# BRITISH GLIDING ASSOCIATION

Tech.Committee.TNS 2/3/79.

Reparaturanweisung DG-100

Reparatur des Lagerbocks RU 19

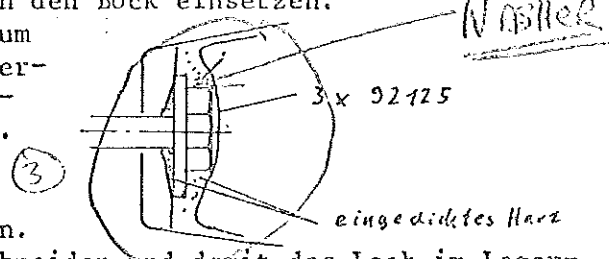
1. Den Höhensteuerumlenkhebel demontieren.
2. Ein Loch von oben in den Bock fräsen. Dabei s. Skizze Abstand zu den Seiten halten.

3. Das Gewebe hinter dem Schraubenkopf wegschleifen. Werkzeug. Hochtouriger Schleifer mit Schleifkopf  $\varnothing$  14mm. Körnung 60-80.

4. Die Schraube herausschlagen.
5. Den Bock innen an der Stelle des Schraubenkopfes aufräumen.
6. Schraube M6 x 35 LN 9037 mit Scheibe 6,4 DIN 9021 entfetten, an Einklebestelle etwas anrauen und mit eingedicktem Harz in den Bock einsetzen.
7. eingedicktes Harz um den Schraubenkopf herum angeben. 3 Lagen 92125 auf einer Folie außerhalb laminieren. Ein Stück 30mm x 30mm ausschneiden und über den Schraubenkopf legen.

8. Bock außen 20mm um das Loch herum aufräumen.
9. Ein passendes Stück aus den 3 x 92125 ausschneiden und damit das Loch im Lagerbock wieder schließen. Dabei Überlappung min. 15mm einhalten.
10. Mindestens 12h bei 20° C Raumtemperatur aushärten lassen.
11. Den Umlenkhebel wieder montieren. Eine neue Stoppmutter M 6 DIN 985 verwenden.

The above is reasonably obvious better way to carry out 301/6. Should the washer have been omitted and the part loose fig (3) would apply
